CITY OF PORT LAVACA

MEETING: JUNE 12, 2023 **AGENDA ITEM** _____

DATE: 06.08.2023

SUBJECT: At the recommendation of the Planning Board, consider and discuss approval of a replat and conceptual plan for a fast-food restaurant for Lot 2A, Block 1, of the Janav Subdivision (1782 State HWY 35 N).

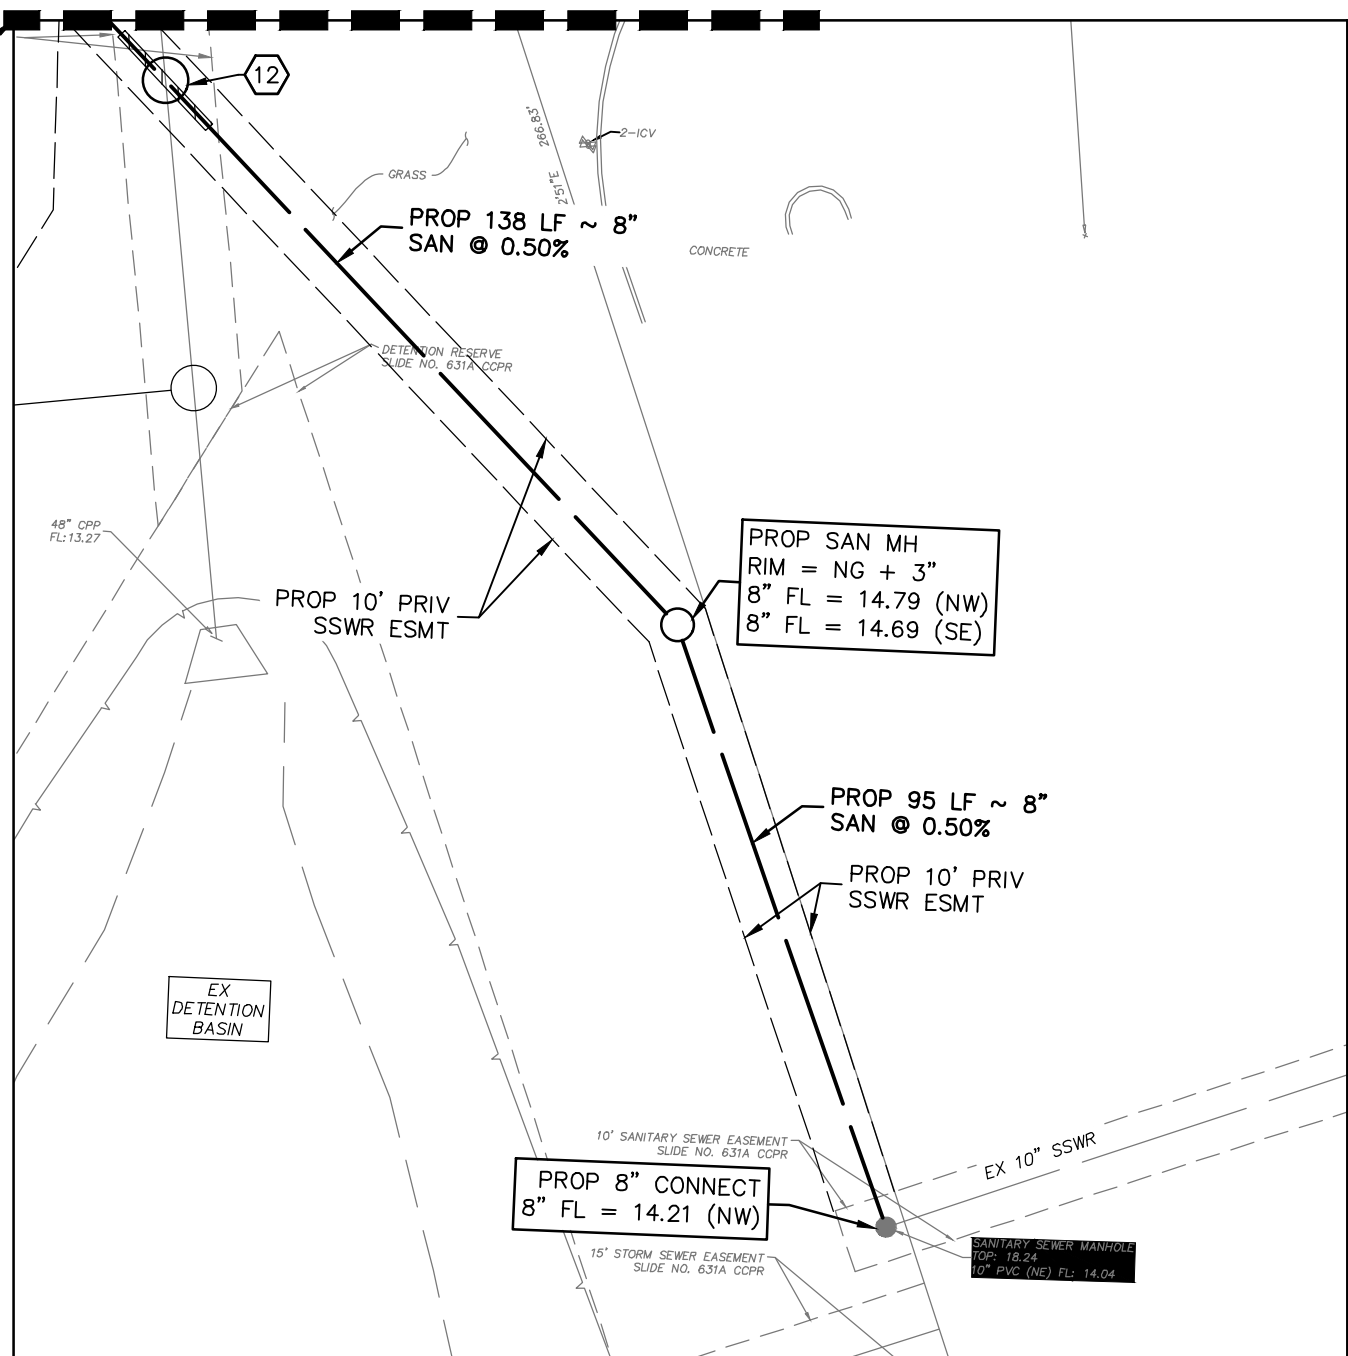
COORDINATE WITH OWNER
ON IF STUB IS TO BE
PROVIDED. OFFSITE FORCE
MAIN WILL BE REQUIRED
IN ORDER TO TIE-IN TO MH

UTILITY PLAN

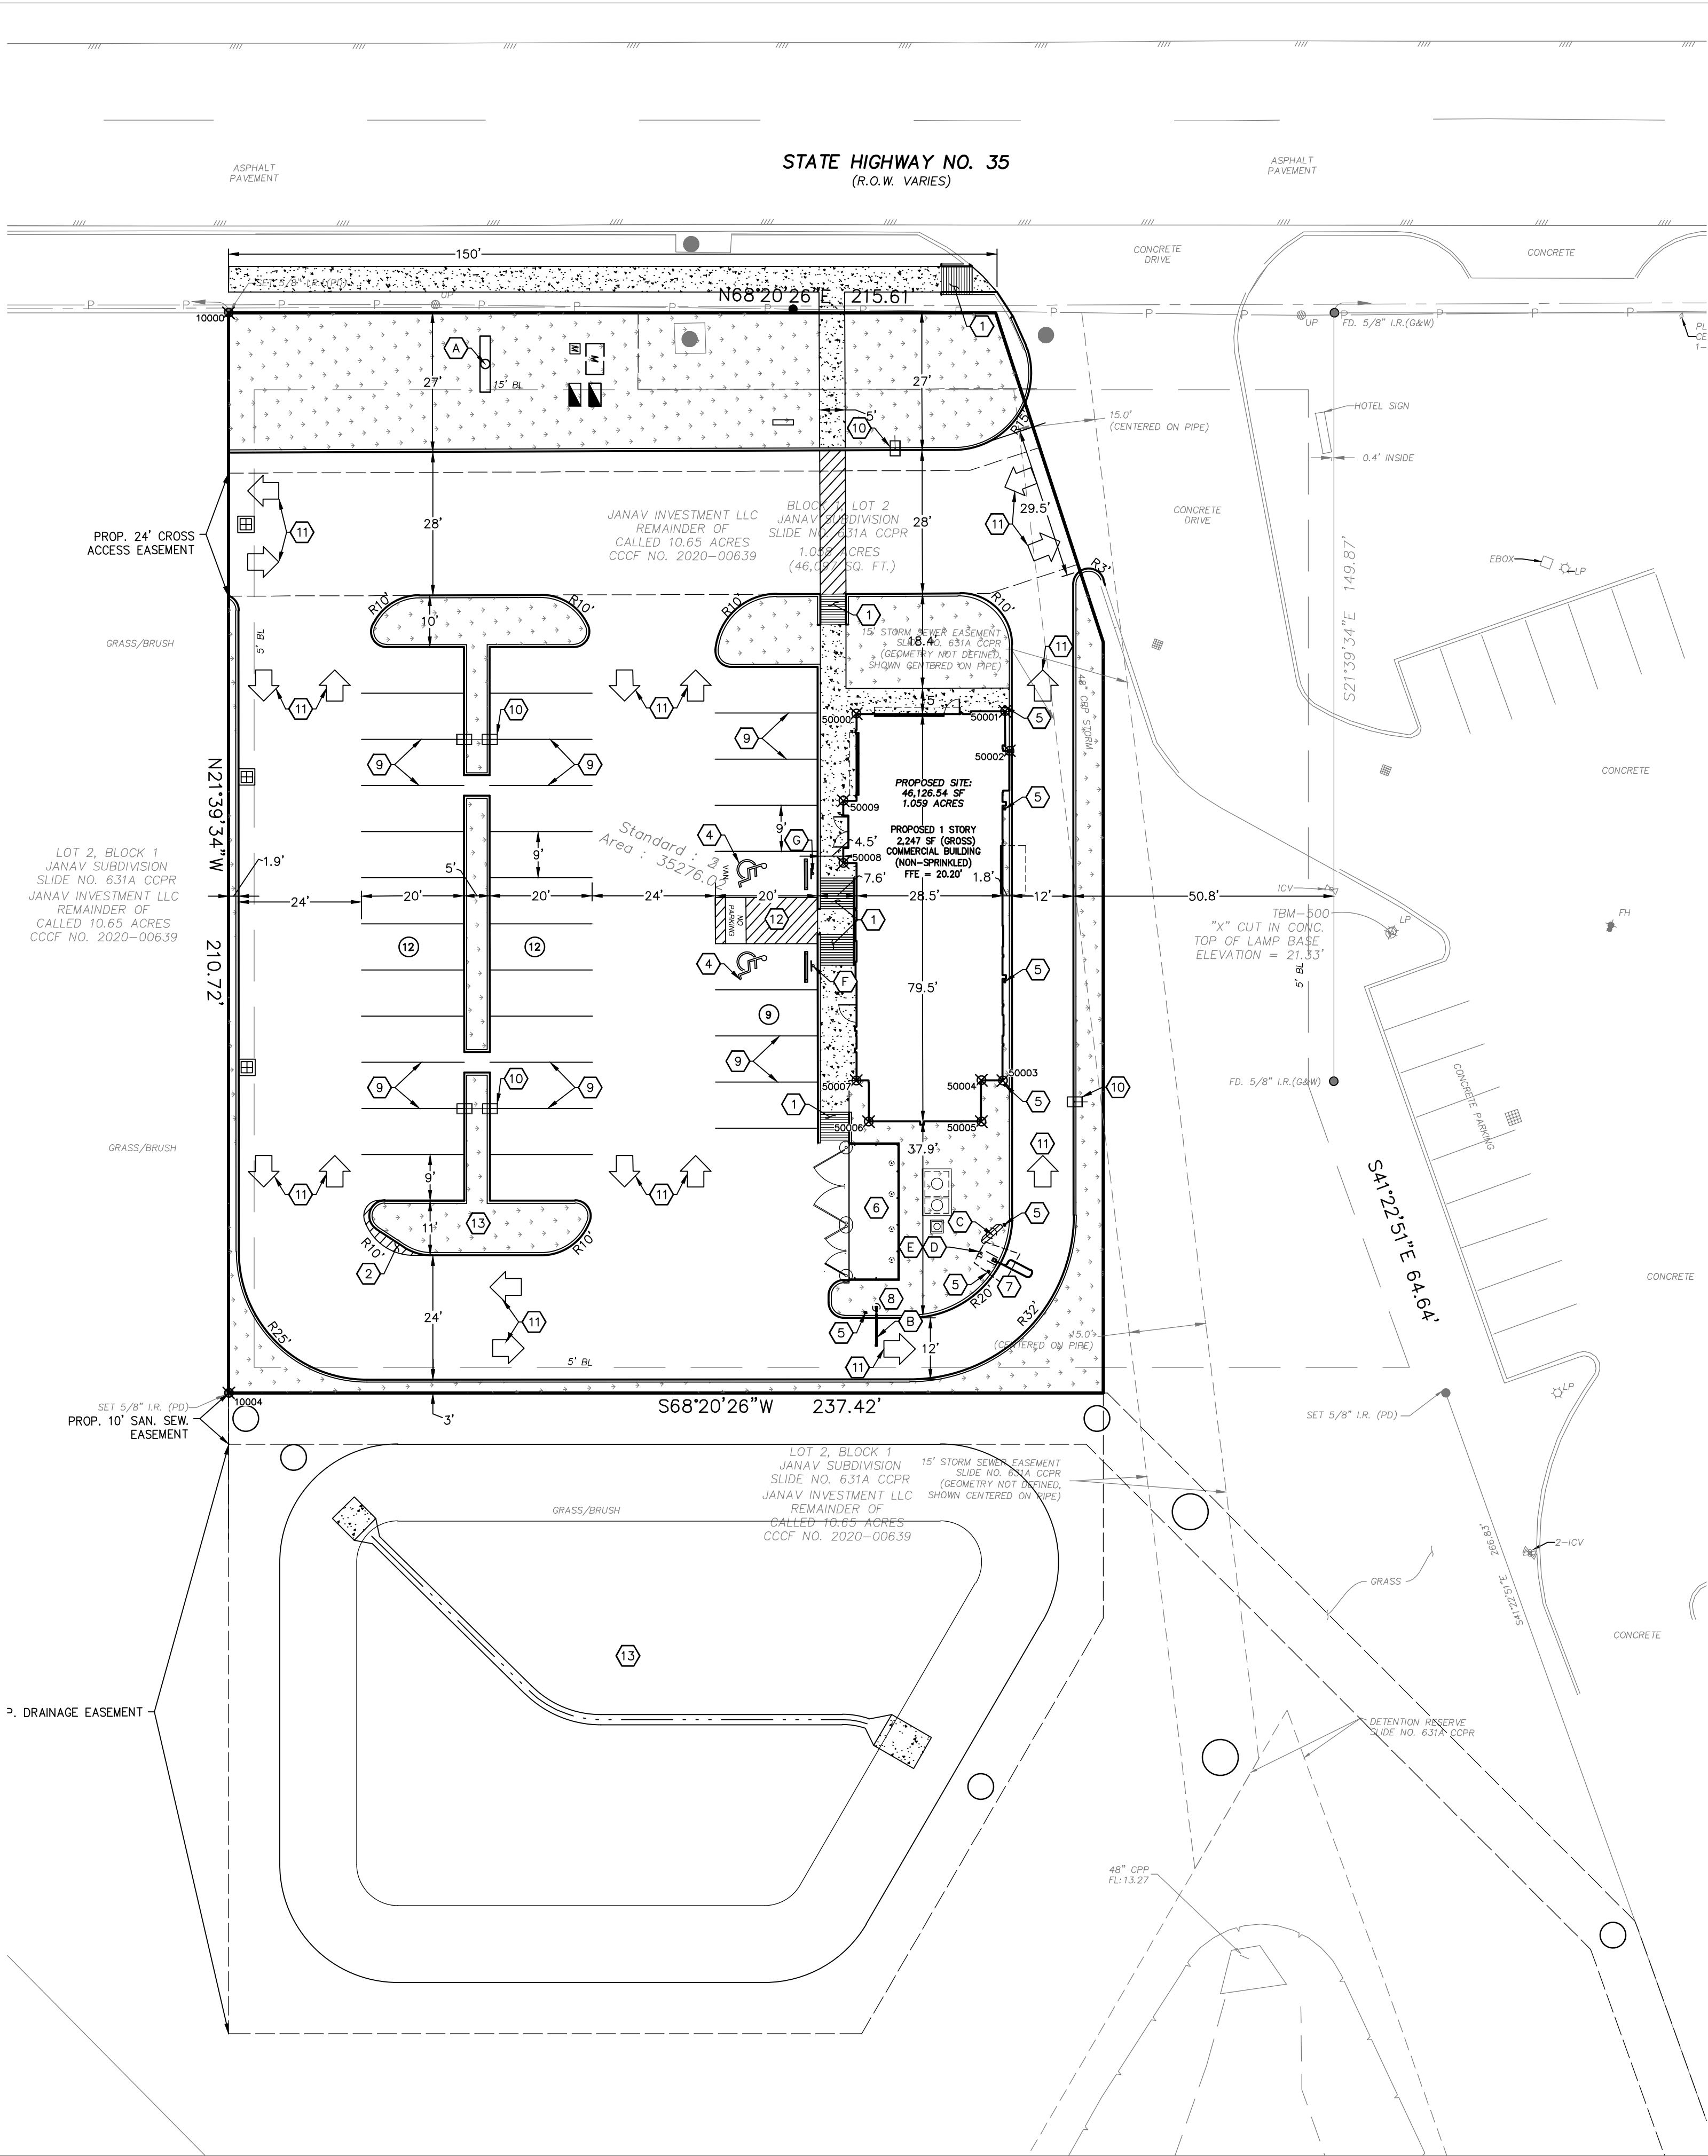
Engineering: A replat must show sanitary sewer and storm water services shared by the adjoining property owner. The seller (adjacent property owner) is providing access to the existing detention pond for an enlargement in order to handle the runoff from this Lot 2A. The seller is providing access to the public sewer system via a private sewer line that drains to the public sewer on SH 238 (the same line that serves Hampton Inn.

Public Works: The Lot has access to public water and public sewer via a private sewer line.

Staff Recommendation: approval of the submitted conceptual plan and, with consideration of the commitment letter from the seller to provide access to the private sanitary sewer and storm sewer facilities, approve the Partial Replat for a fast-food restaurant for Lot 2A, Block 1, of the Janav Subdivision (1782 State HWY 35 N), with the stipulation that a revised replat is submitted and recorded showing all private easements in the Janav Subdivision prior to issuance of the Certificate of Occupancy for Lot 2A.
